UNITED STATES PATENT AND TRADEMARK OFFICE

APPLICATION NO.	FILING DATE	FIRST NAMED INVENTOR	ATTORNEY DOCKET NO.	CONFIRMATION NO.
10/773,107	02/05/2004	Chris Rhodes	60130-2016; 02MRA0393	3984

Office Action Summary

DETAILED ACTION

FIG. 4

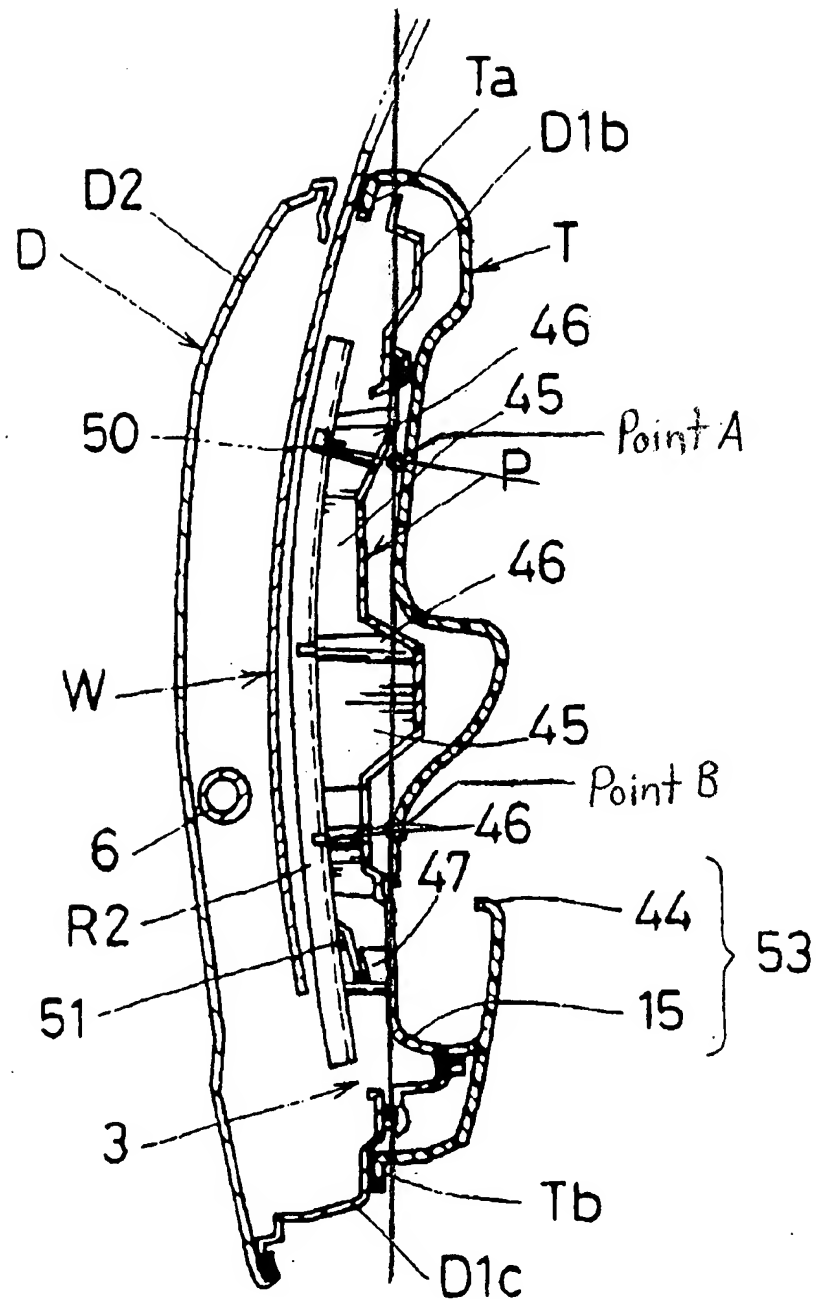
Nishikawa et al. disclose a door module with a window regulator rail (R2) and a trim panel (P). The window regulator rail (R2) can be separably fixed to the trim panel (P). The window regulator rail (R2) is fastened to a part of the door, the trim panel (P). A line projecting from the point where the window regulator rail (R2) is attached to the trim panel (P) and perpendicular to the window regulator rail intersects a plane defined by the trim panel at a point outside of the trim panel, as seen in the Attachment of this office action. In reference to claim 3, a window regulator (R1) is disclosed and the window regulator rail (R2) is a guide rail. In reference to claim 4, an electric window regulator control (40) is attached to the trim panel (P) and has wires that connect it to the window regulator (R1). In reference to claim 7, Figure 4 shows the window regulator rail attached to the trim panel (P) in an upper region of the window regulator rail (R2). In reference to claim 8, a second fastening point is located on the lower region of the window regulator rail (R2) where the rail (R2) is connected to the trim panel (P). In reference to claims 9 and 10, a lock (33) and a door handle (30) are detachably mounted to the trim panel (P). The door handle (30) actuates the lock (33).

8. The applicant has argued that the 35 USC 102(e) rejections based on Nishikawa et al. do not anticipate the claimed invention. The examiner has reviewed the rejection and realized that the plane defined in Attachment 2 of the previous office action was incorrect. This rejection has been rewritten and a new illustration has been attached that corrects this error. The window regulator rail (R2) is connected a panel (P) that meets the claimed limitations of the door trim. The panel (P) is part of the door. The fastening point defined by this connection meets the limitation of having a line extending perpendicularly from the rail to intersect the plane defined by the trim outside the door trim.
